BELMONT OAKS SUBDIVISION

The preliminary plat illustrates the proposed 119-lot, 36.6± Acre subdivision located at the Northwest corner of Dawes Lane Extension and Labrador Trail, within the Planning Jurisdiction. The applicant states the subdivision is served by public water and sanitary sewer systems (South Alabama Utilities).

APPLICATION NUMBER 3 DATE June 7, 2018

DETAIL SITE PLAN

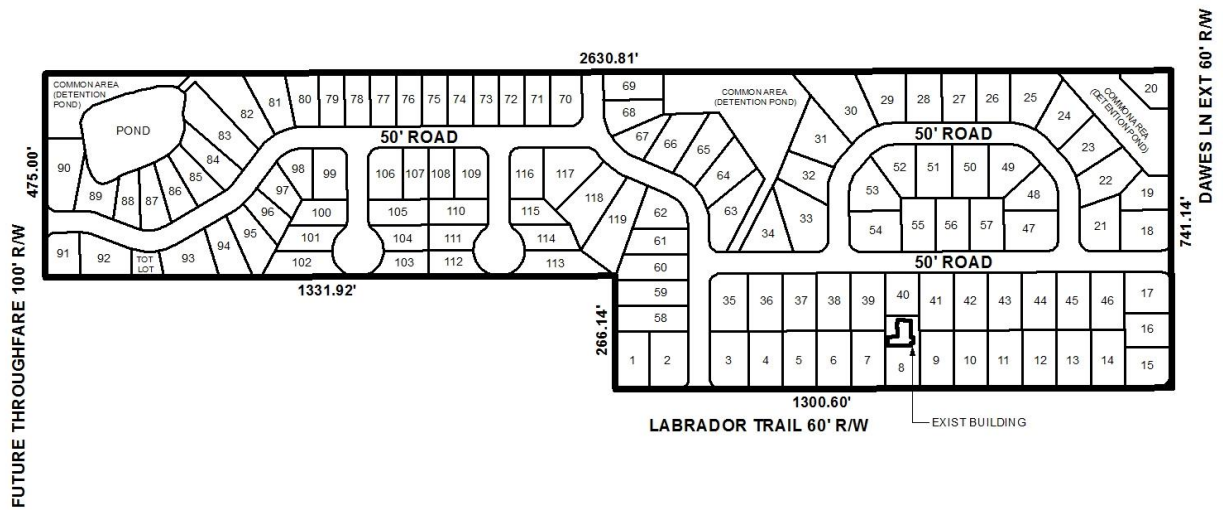
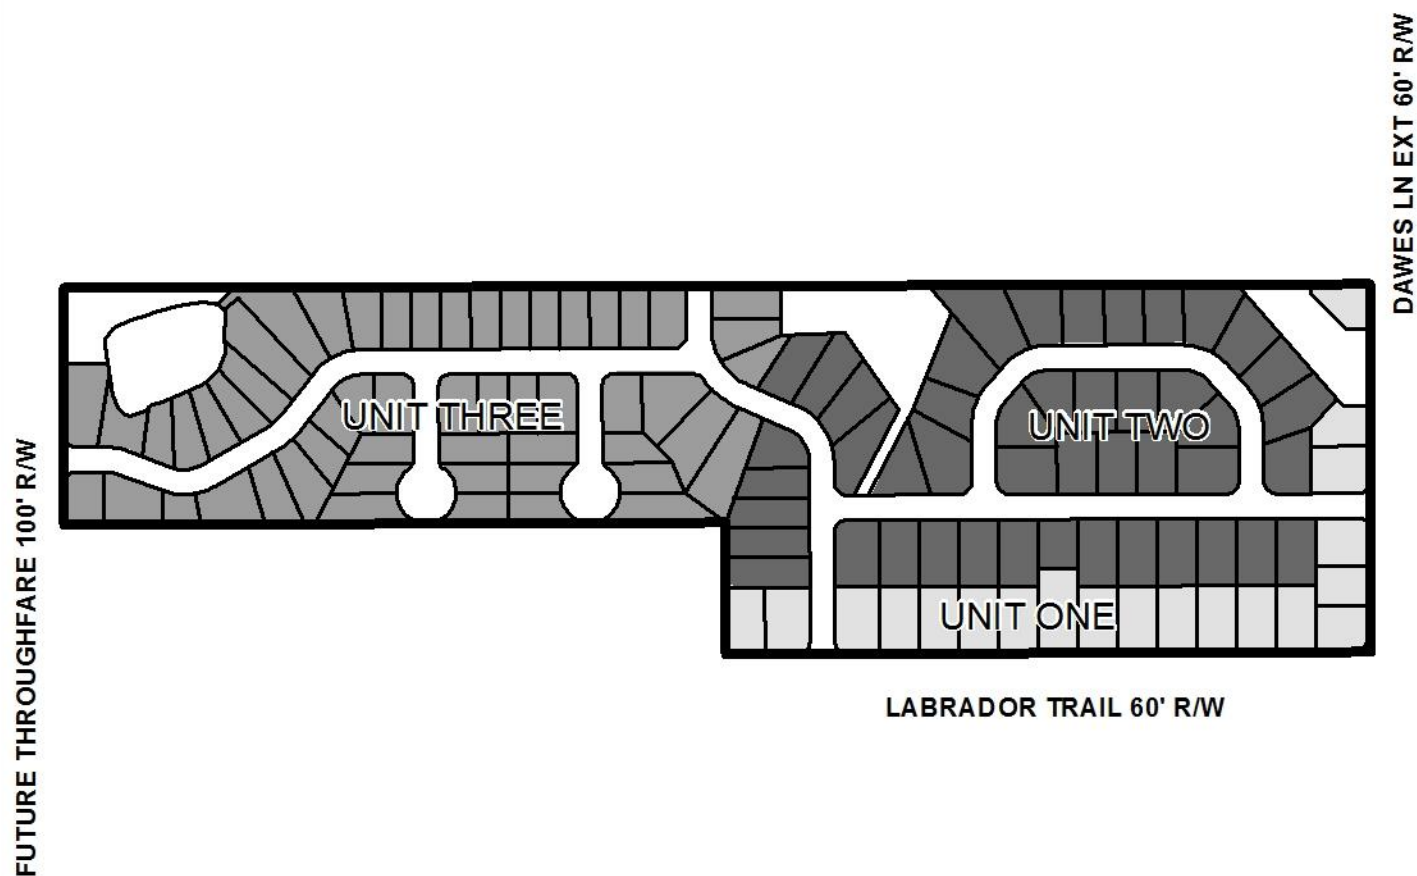
Because large subdivisions inherently generate additional traffic as a result of additional vehicles having access to existing streets, it may be appropriate to limit access to Dawes Lane Extension. Revision of the plat to reconfigure or remove Lots 16, 19, and 20, as well as the Common Areas along Dawes Lane Extension and the proposed Airport Road extension will be necessary to do so. Additionally, access to all of the proposed lots should be limited to one (1) curb cut each. A note should, therefore, be placed on the Final Plat, if approved, stating each lot and Common Area is denied access to Dawes Lane Extension and the proposed Airport Road extension, and is limited to one (1) curb cut each to their respective unnamed roads along which they have frontage, with any changes in their sizes, locations, or designs to be approved by Mobile County Engineering and conform to AASHTO standards.

The 25' minimum building setback line is not illustrated along the frontage of any proposed lot or Common Area, as required by Section V.D.9. of the Subdivision Regulations. If approved, the plat should be revised to illustrate the 25' minimum building setback line along all street frontages, adjusted for any required dedication.

Many of the proposed lots are slightly irregularly shaped, which is seemingly the result of the design of the proposed connector streets, but none of the lot sizes are provided; therefore, it is difficult for Staff to determine if they will meet the minimum size requirements for lots served by public water and sanitary sewer systems. The sizes of the proposed Common Areas are also not provided. Additionally, many of the proposed lots do not appear to meet the minimum width requirements of the Subdivision Regulations, and not all lot widths are illustrated. A note on the plat states there is a 60' minimum lot width at the setback line, but without illustration of the setback line, staff cannot verify the remark. If approved, revision of the plat to provide the sizes of each lot and Common Area, as well to provide the widths of each lot and Common Area along each street on which they have frontage should be required, adjusted for any required dedication; or, provision of a table on the Final Plat providing the same information may suffice.

Regarding what is labeled as the “Tot Lot,” its purpose to the subdivision has not been identified by the applicant, and it does not meet the minimum size requirements for lots served by public water and sanitary sewer systems. As such, revision of the plat to label the “Tot Lot” as Common Area may be appropriate.

- 1) revision of the plat to provide or illustrate a definite plan/layout for each subdivision phase;
- 2) revision of the plat to accommodate the proposed 120’-wide right-of-way of the Airport Road extension per the Major Street Plan, including the necessary dedication of land to Mobile County;
- 3) revision of the plat to illustrate right-of-way widths in compliance with Section V.B.14. of the Subdivision Regulation along all proposed streets within the subdivision;
- 4) revision of the plat to ensure no proposed lots or Common Areas have access to Dawes Road Extension;
- 5) revision of the plat to ensure no proposed lots or Common Areas have access to the proposed extension of Airport Road;
- 6) revision of the plat to provide the sizes of each lot and Common Area in both square feet and acres, or the provision of a table providing the same information;

- 7) revision of the plat to clearly identify the widths of each lot, and the widths of the access to each Common Area, as reconfigured on the revised plat;
- 8) provision of the 25' minimum building setback line along all street frontages where lots and Common Areas are at least 60' wide; and,
- 9) revision of the plat to label the "Tot Lot" as a Common Area.

Staff recommends Withdrawal of the application until such time the applicant can address the concerns of the Planning Commission.
